07 EPA ENGINES
DIPLOMAT/ENDEAVOR - ISL
KNIGHT/AMBASSADOR - ISC
CAYMAN/NEPTUNE - ISB
LAPALMA/VCATIONER - ISB

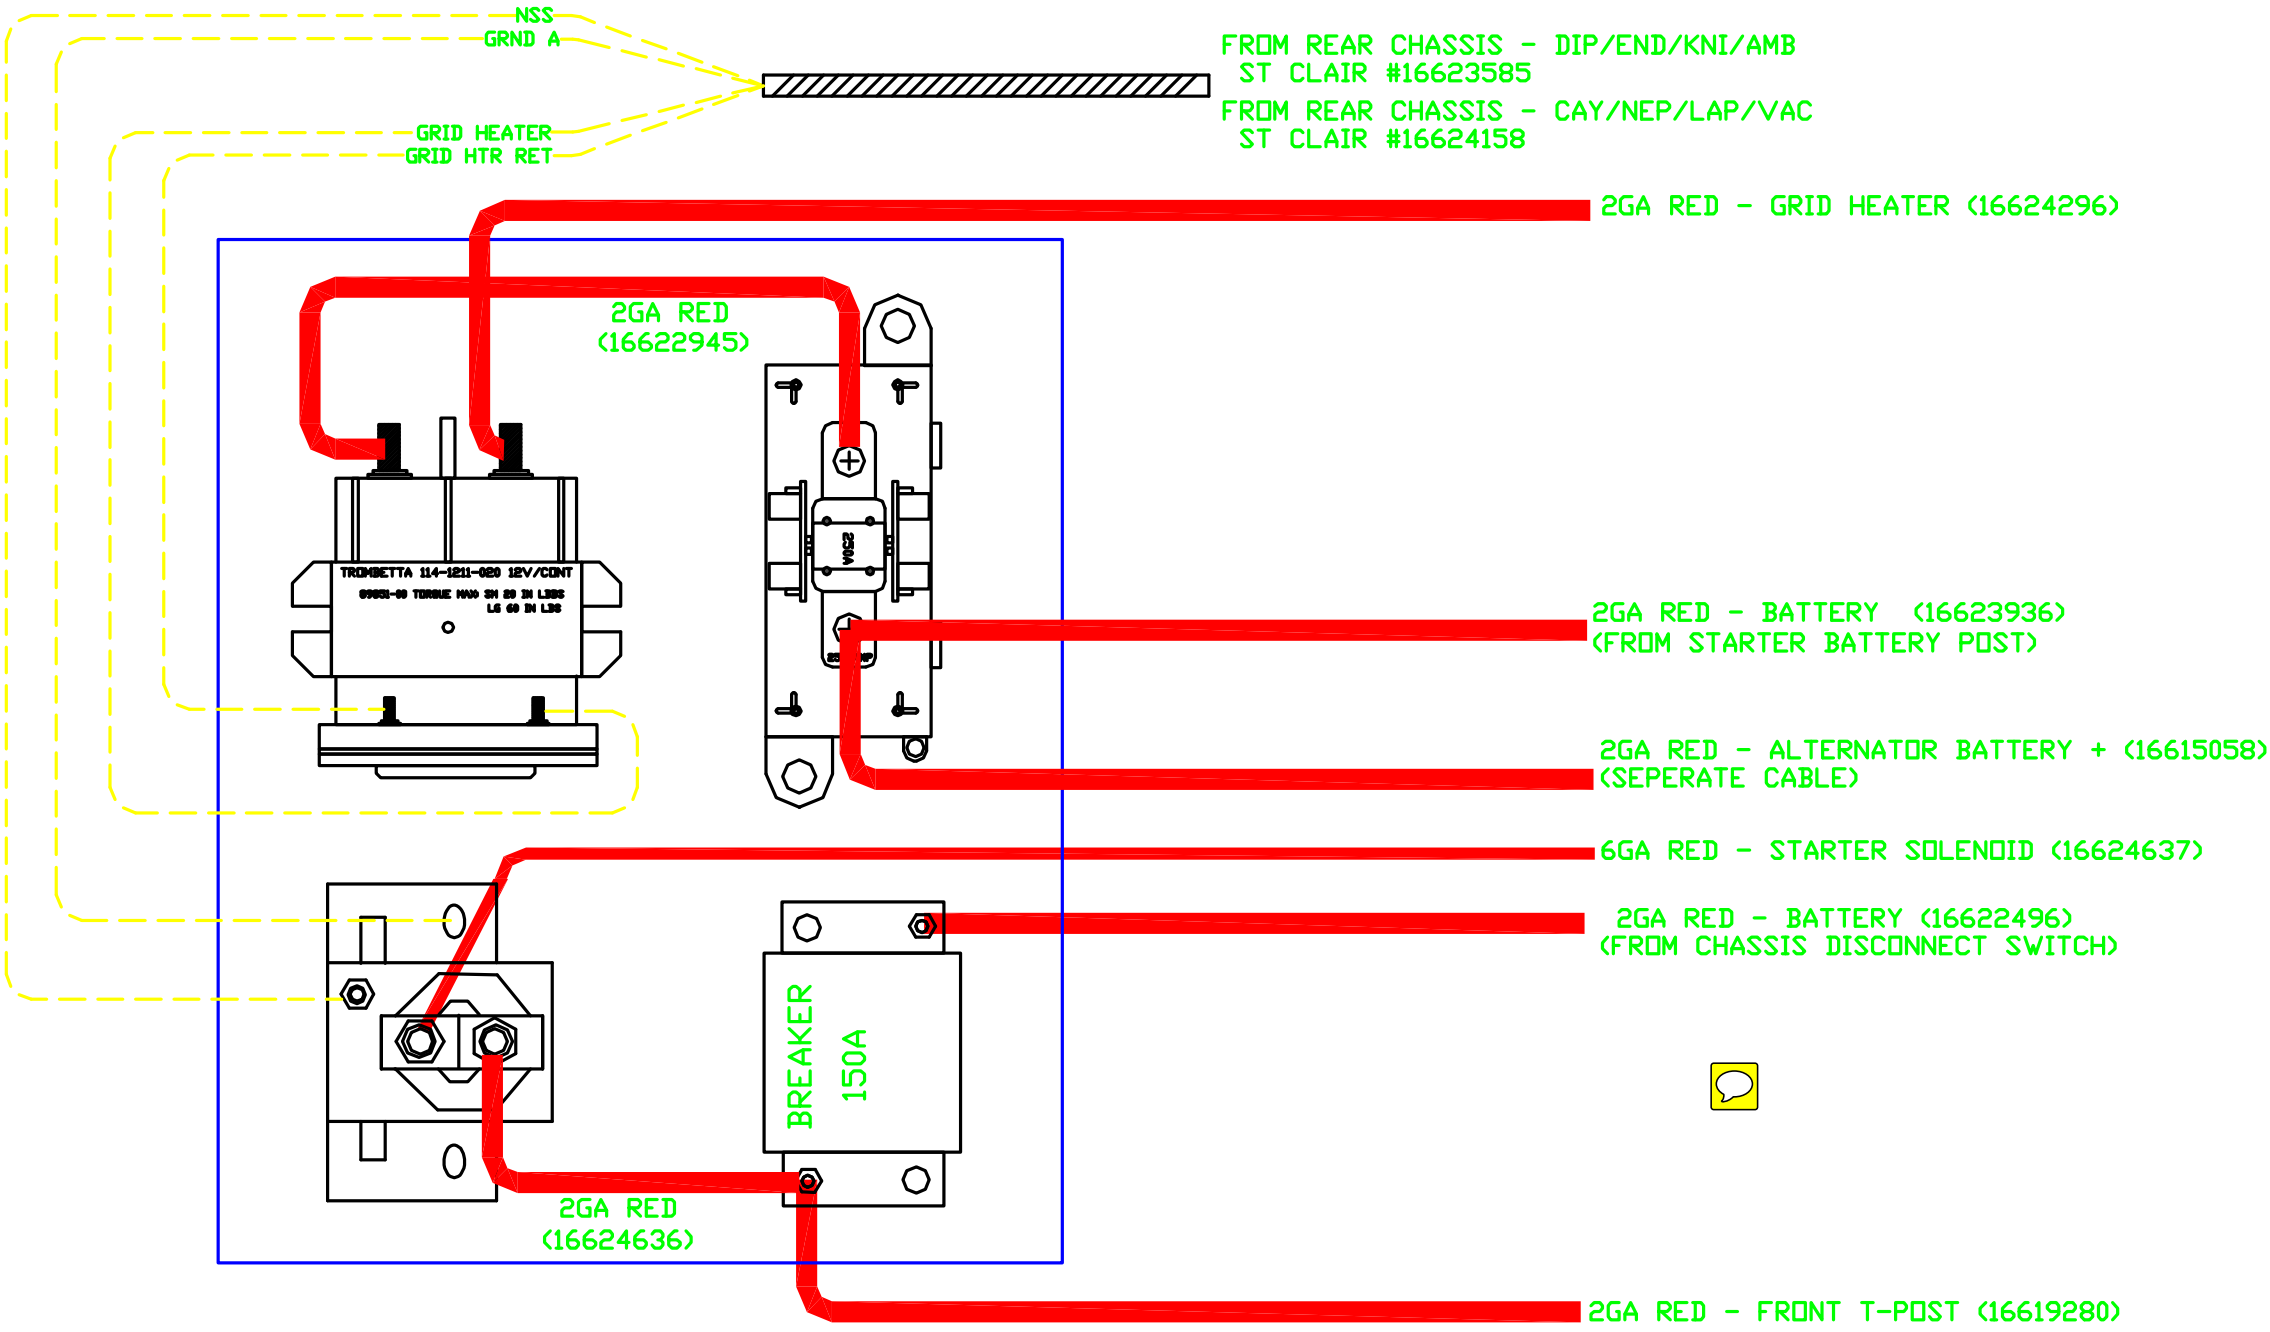
REV.	UNIT	DESCRIPTION OF CHANGE	BY	DATE
1	-	CHANGED FUSEHOLDER AND SOLENOID MANUFACTURERS, ADDED		
		BATTERY CABLE PART NUMBERS	RNB	2/19/07
2	-	ADDED MISSING BOM INFO, ROTATED SOLENOID	RNB	2/19/07
3	-	CHNGD STRT SOL WIRE GA, ADDED ISB NOTE, STRT SOL NOW 6GA	RNB	4/24/07
